## **One Earth Solar Farm**

**Applicant Response to ExA's First Written Questions**

Document Ref: EN010159/APP/9.19

August 2025

Applicant Response to ExA's First Written Questions (Q19.0.2)

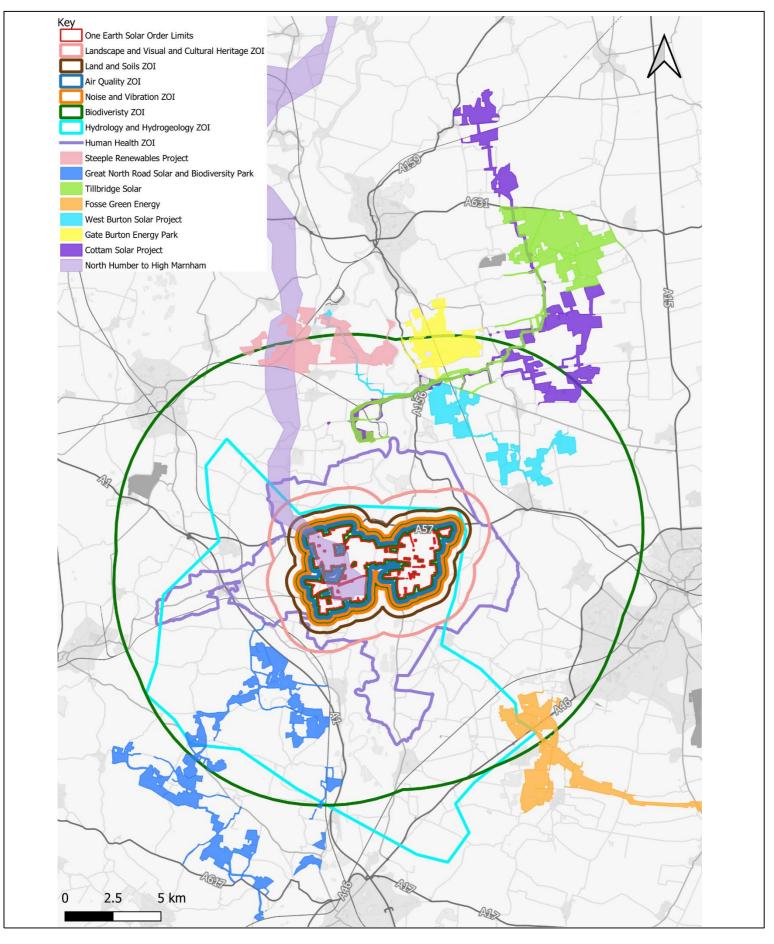
ExA Q Ref	Respondent	Question Summary	Applicant Response
Cumulative	e Effects		
Q19.0.2	The Applicant	Cumulative Effects In the first bullet point under paragraph 18.5.22 of Chapter 18 of the ES reference is made to the siting of a substation. Please provide a plan identifying where this is proposed to be located.  Two schemes are identified as having potential cumulative effects – a solar farm ref 21/01577/FULM and the North Humber to High Marnham NSIP. Please provide plans identifying their respective red edge outlines, (accepting that the NSIP is yet to be applied for, the most up to date red edge currently available).	As set out in paragraph 18.5.18 of ES Chapter 18: Cumulative Effects [APP-047], the DCO application does not include proposals for the new substations, which will instead be brought forward through separate applications. Whilst the location of the substation is unknown, the latest available information assumes the substation could be located anywhere west of the existing High Marnham substation in Work Area No. 4. Given this uncertainty, the cumulative assessment has adopted a conservative approach, considering the potential for the substation to be located in any part of this area, to the west of the existing substation in Work Area No 4. The cumulative assessment has reported the worst-case effects accordingly.  A plan showing the red edge outlines of the two schemes, along with the Proposed Developments Order Limits, is provided in Figure 1 included within this response.
